Manitowoc® Parts & Service Communicator

Subject: QDUALC Safety Limit #1 Caused by Prematurely Satisfied Water Level Probe

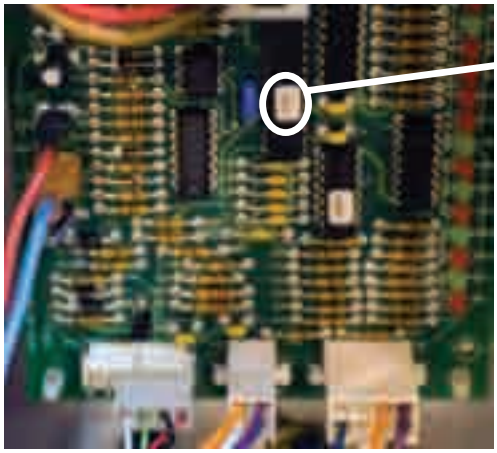
Units built before Serial Number 040260338 use the Q Style Water Level Probe.

A. Regardless of where it is presently mounted it now must be mounted to the back wall of the ice machine. If it is defective replace it with part number 25-1129-3. If the probe is located at the front of the water trough or the middle of the sump trough order Q Style Water Level Probe Relocation Kit # 76-0293-3.

B. Replace the control board (if not already done so) with a current production control board part #76-0120-3. The current control board has a sticker on the microprocessor with the number 121. A board with any other number could cause this symptom and must be replaced with one that does have the sticker with the number 121.

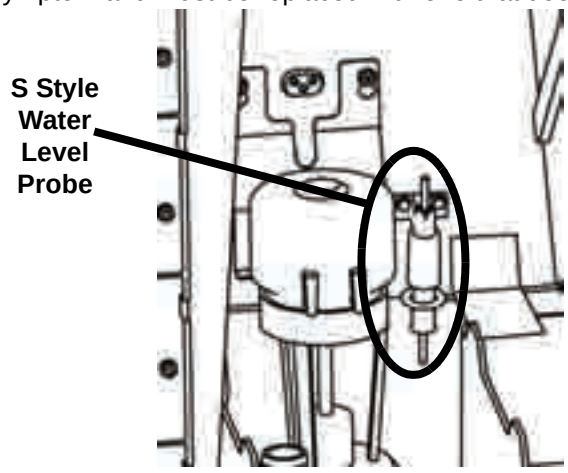
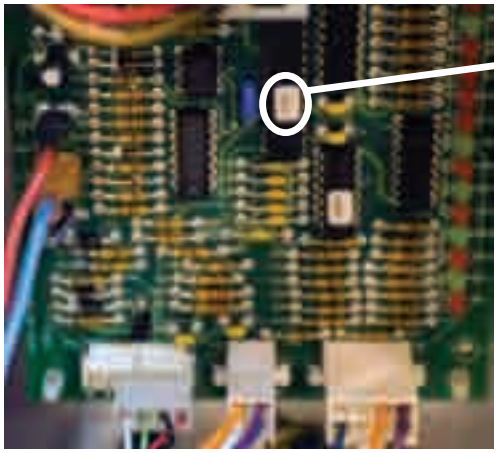
Units built with Serial Number 040260338 or later use an S Style Water Level Probe mounted to the back wall.

A. If you diagnose the probe to be defective replace it with the S Style Water Level Probe part number 20-0654-9.

B. Replace the control board (if not already done so) with a current production control board part #76-0120-3. The current control board has a sticker on the microprocessor with the number 121. A board with any other number could cause this symptom and must be replaced with one that does have the sticker with the number 121.
